Applicant:
Pi'ilani Promenade North, LLC
Pi'ilani Promenade South, LLC
c/o Sarofim Realty Advisors
8115 Preston Road, Suite 400
Dallas, Texas 75225

Consultant:
Chris Hart & Partners, Inc.
Attn: Jordan Hart
115 North Market Street
Wailuku, HI 96793

Re: DEIS for Pi'ilani Promenade TKM: (2) 3-9-001: 016,170-174

FIGURE 15
Conceptual Circulation Plan
Piilani Promenade
Source: Architects Orange

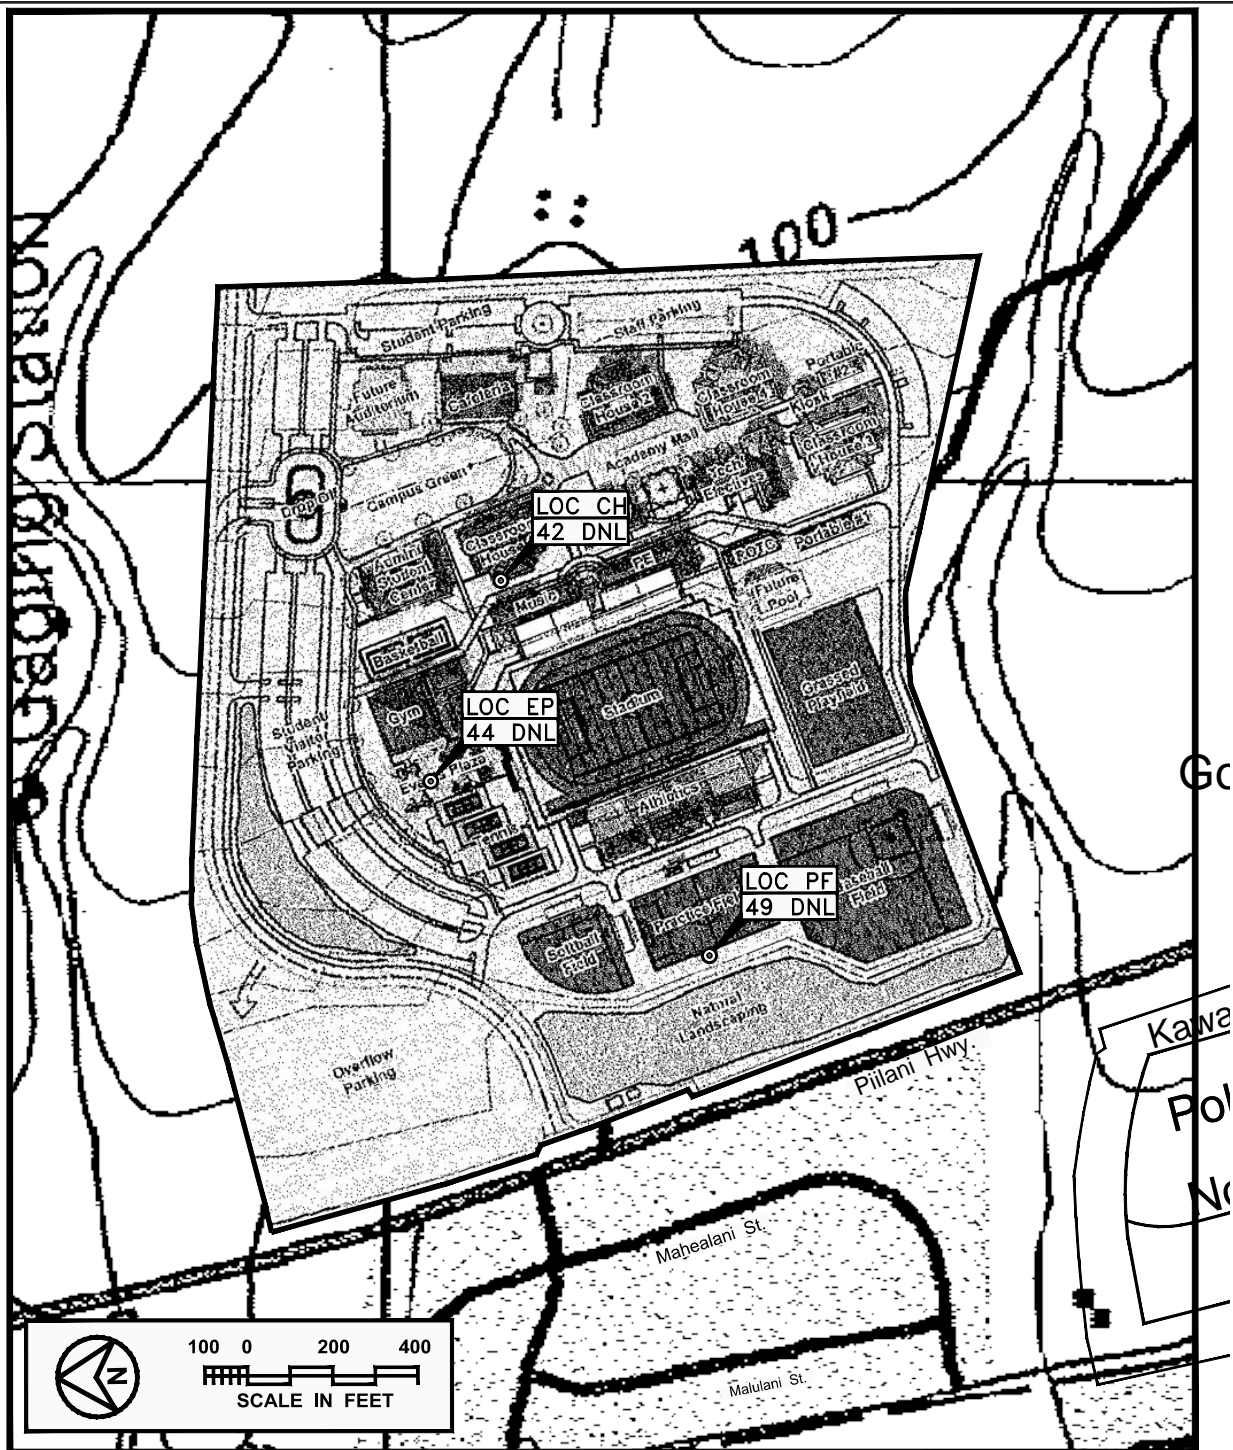
Comment: Will the roadways, bicycle, and pedestrian paths actually connect with any adjoining properties, or merely give "future opportunities." How will the 1995 Land Use Commission (LUC) condition requiring a frontage road connecting to neighboring properties be fulfilled if the project is not successful in amending its LUC Decision to delete this condition? We ask the FEIS to address this.

Comment: This roadway is described as serving as a four-lane divided highway but pedestrian access across the four lanes, both to the project site and the new Kihei High School, is not discussed in the DEIS. Instead, the school access is listed as an "unresolved issue." It should be considered an impact requiring mitigation.

The current Project plan includes off-road pedestrian and bicycle routes along both East Kaonoulu Street as well as through an access easement from Ohukai Street to East Kaonoulu Street. Additionally, the Project includes a separate pedestrian/bicycle pathway running parallel to the Pi'ilani right of way within the project property as a preferred and safe route for south Maui residents traveling to and from the project area. With regard to the Kulanihakoi Gulch crossing, the project owner has offered to assist the State DOT in the design of a separate crossing facility located within the right of way and outside the roadway section for pedestrian and bicycle safety. All of the above proposed improvements are intended to facilitate safe walking and bicycling and to reduce the requirement for automobile use in order to access the development. (See: Figures 14 A "Piilani Hwy Existing Street Section" and 14B "Piilani Hwy Proposed Street Section")

However, the current Project plan includes off road pedestrian and bicycle routes along both East Kaonoulu Street, as well as through an access easement from Ohukai Street to East Kaonoulu Street. Additionally, the Project includes a separate pedestrian/bicycle pathway running parallel to the Pi'ilani right of way within the Project site as a preferred and safe route for south Maui residents traveling to and from the Project site. With regard to the Kulanihakoi Gulch crossing, the Applicant has offered to assist the State DOT in the design of a separate crossing facility located within the right of way and outside the roadway section for pedestrian and bicycle safety. All of the above proposed improvements are intended to facilitate safe walking and bicycling and to reduce the requirement for automobile use in order to access the development.

FIGURE 18
Noise Impact Map 5A

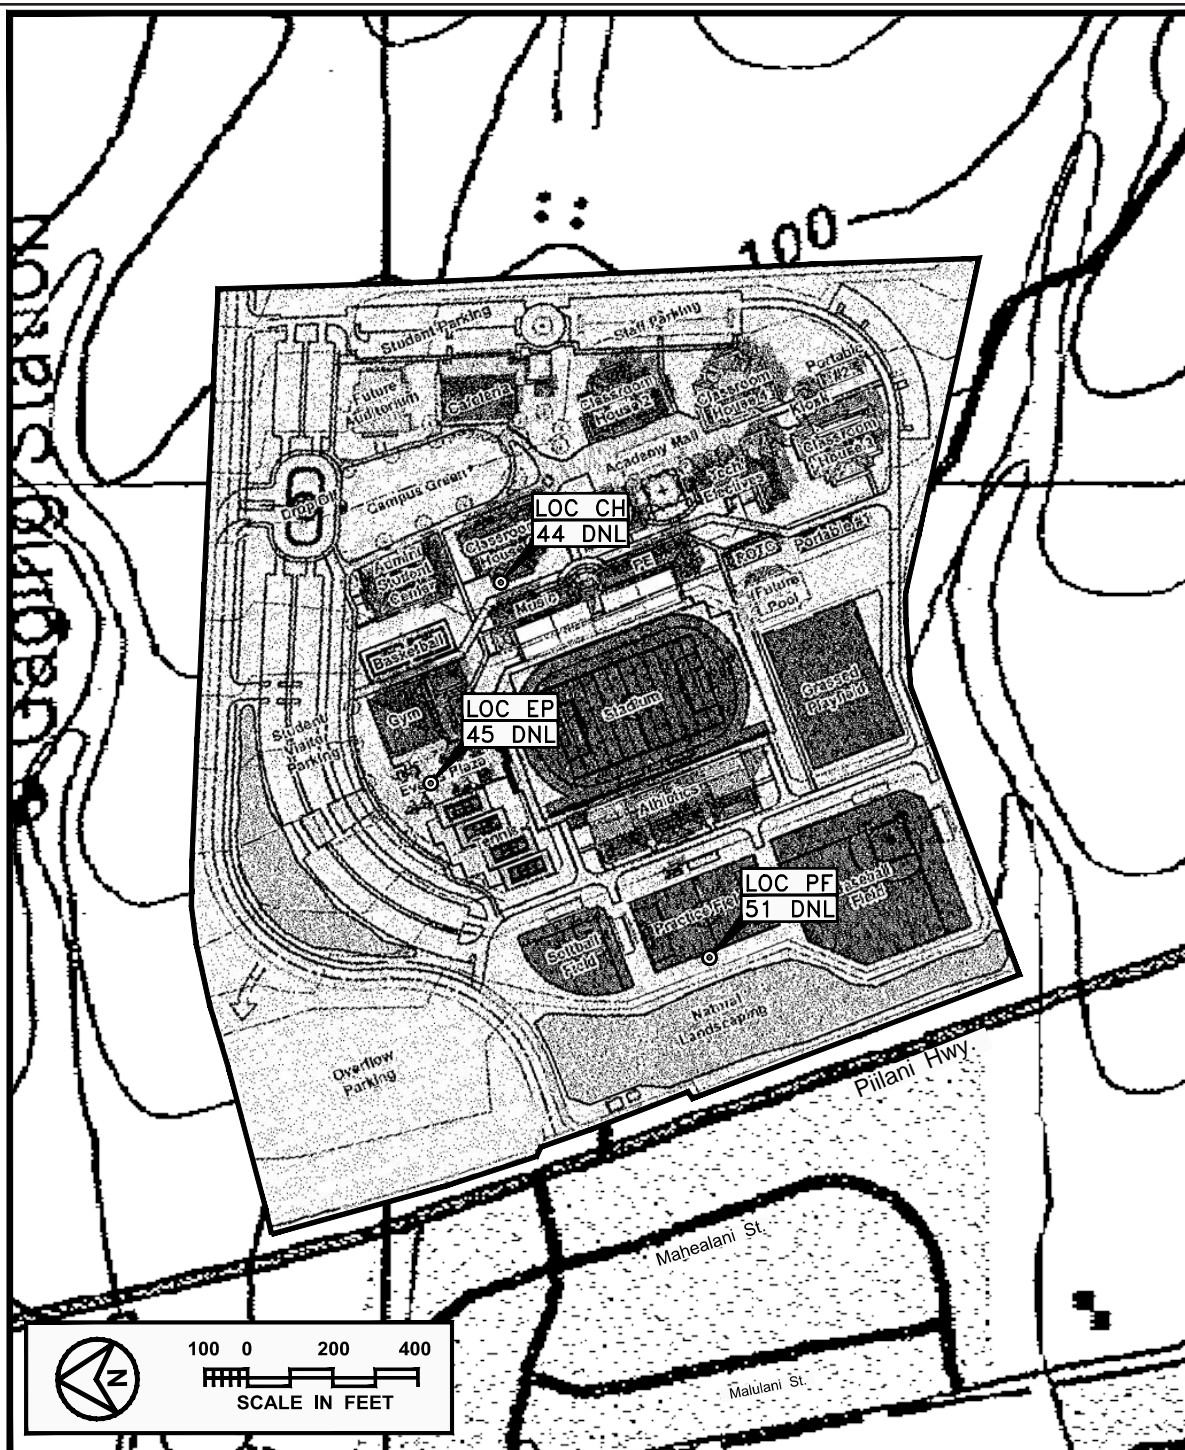
Comment: The DEIS does not address how increased noise levels from Piilani Highway or the future Kihei-Upcountry Highway (KUH) will affect the new Kihei High School.

Figures 18 (Noise Impact Map 5A) and 19 (Noise Impact Map 6A) were prepared by Y. Ebisu & Associates and show the predicted traffic noise levels at 3 locations on the proposed high school site. Both existing and future (2032) traffic noise levels from Pi'ilani Highway should be less than 55 DNL at the proposed Kihei High School facilities due to adequate setback distances provided from Pi'ilani Highway. Adverse traffic noise impacts at the proposed high school are not anticipated for this reason.
